BUSH FIRE ASSESSMENT REPORT

Lot 69, 70 and 71 DP 230448

5-7 McDermott Avenue & 1 Phillip Street Goonellabah

Proposed three storey 20 unit residential development and strata subdivision, and possible consolidation of existing three allotments into one allotment

Concept Landscape Plan

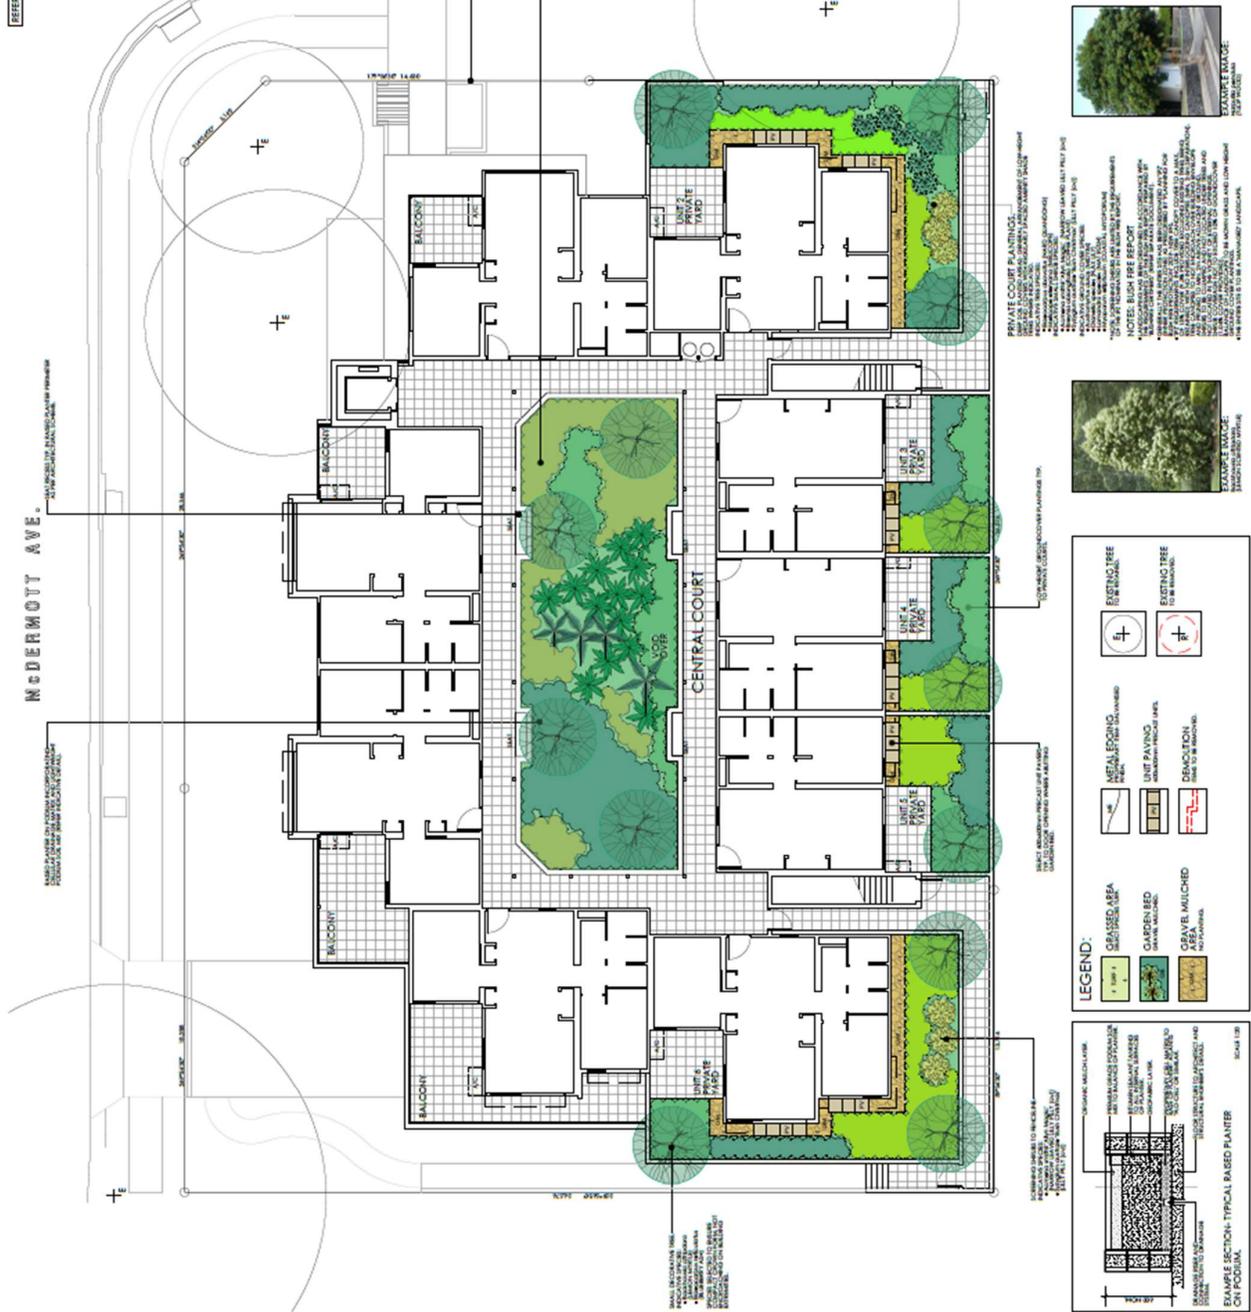
Concept landscape plans DWG No. 1014-LCP01 and 02 Rev B dated 29.01.24 prepared by Alderson and Associates Landscape Architects was received for review and comment relating to compliance with the landscape recommendation.

An assessment of the concept plans shown in Appendix B of this report has been undertaken. It is noted the assessment is limited given the insufficient detail of a concept plan with further assessment required when fully detailed plans are provided to the consent authority for approval.

The assessment established that the concept plan has the potential to be amended to achieve compliance. The following is a summary of amendments required for the final detailed landscape plans to be submitted and approved by the consent authority.

- The non-combustible path around the perimeter of the building is to be increased from 600mm to a minimum 1000mm.
- Remove reference to organic mulch in the raised planter section on Level 2 Plan.

- Provide a specific detail of shrub and ground cover plantings demonstrating plantings are located twice the mature height away from windows and doors, including plantings located below windows on storeys above. For example, the shrubs adjacent to the west elevation and identified in the table on plan have a mature height of 5-8m and are located in close proximity to openings which does not meet IPA requirements.

- The percentage of canopy cover and shrub layer is to be calculated using the percentage of landscaped area rather than the total site area. The central court has been shown with 100% planting coverage. The level 2 private court yards have been shown with greater than 75% planting coverage. In this regard, a performance solution (see appendix C) has been provided for the tree canopy however it relies

upon shrub and groundcover compliance with Appendix 4 PBP2019 in relation to planting location and coverage. Plans to be amended to demonstrate compliance.

- Indicate the location of the proposed vines. It is noted that use of vines is generally not supported in IPA areas, particularly on building structures.
